Design Review Board Case #2016-0001 Carlyle Plaza Two – South Residential Building

Application	General Data	
Project Name:	DRB Date:	March 23, 2017
Carlyle Plaza Two – South Residential Tower	Site Area:	~ 2 acres
Location: 340 & 350 Hooff's Run Drive (ultimately will have a Bartholomew Street address)	Zone:	CDD#11
Applicant: Alder Branch Realty Limited Partnership, LLLP; represented by JM Zell Partners	Proposed Use:	Residential
	Dwelling Units:	366 units
Architect: Arquitectonica	Gross Floor Area:	~ 505,625 sf (400,795 sf res + 104,830 sf parking)
Purpose of Application:		
Design refinements of the first phase of the Carlyl tower).	e Plaza Two devel	opment (south residential
Staff Reviewers: Robert Kerns, AIA, robert.k Thomas H. Canfield, AIA t	om.canfield@alexa	andriava.gov

Renderings of Approved Design

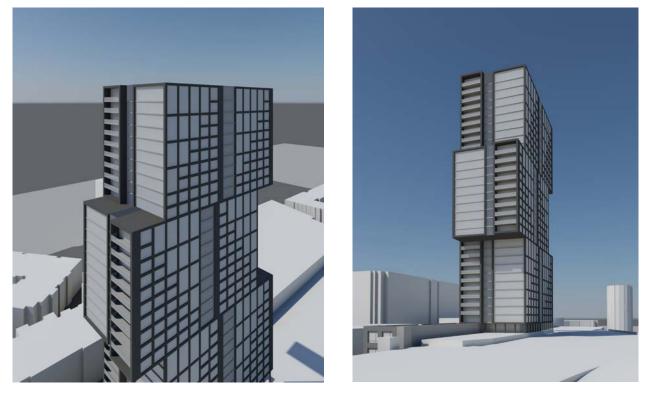
Staff does not support the initially proposed projecting balconies. The form of the building developed by the Applicant's architectural team is a strong, clean, geometric statement that depends upon the preservation of the geometric consistency of the component façades. Staff believes that the architecture of the façade as approved by the Design Review Board in July 2016 represents the best incorporation of the balconies and overall architecture.

Option B – No Balconies

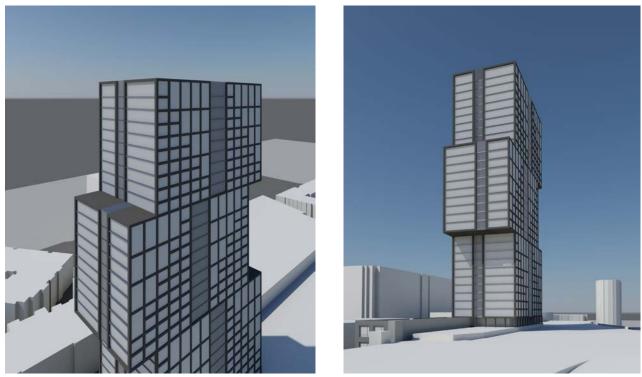
The Applicant is also requesting that the Design Review Board consider an option for the elimination of the balconies entirely (Option B), with the concurrent reduction of the slot

to a condition where the glass is coplanar with the glass on either side, with an approximately 18" depth frame. Staff does not support this option as it is a significant change in the architecture of the façade, resulting in a flat, barely-differentiated appearance that would express little of the distinctive architecture of the approved design.

The remaining design alteration, that of the balconies on the north and south façade, will require further refinement of Option A. Staff recommends rejection of Option B as this is

inconsistent with the design approach to create a strong geometric design, and results in a flat, monotonous appearance. Staff recommends that the Design Review Board indicate their general acceptance of Option A and provide commentary accordingly.
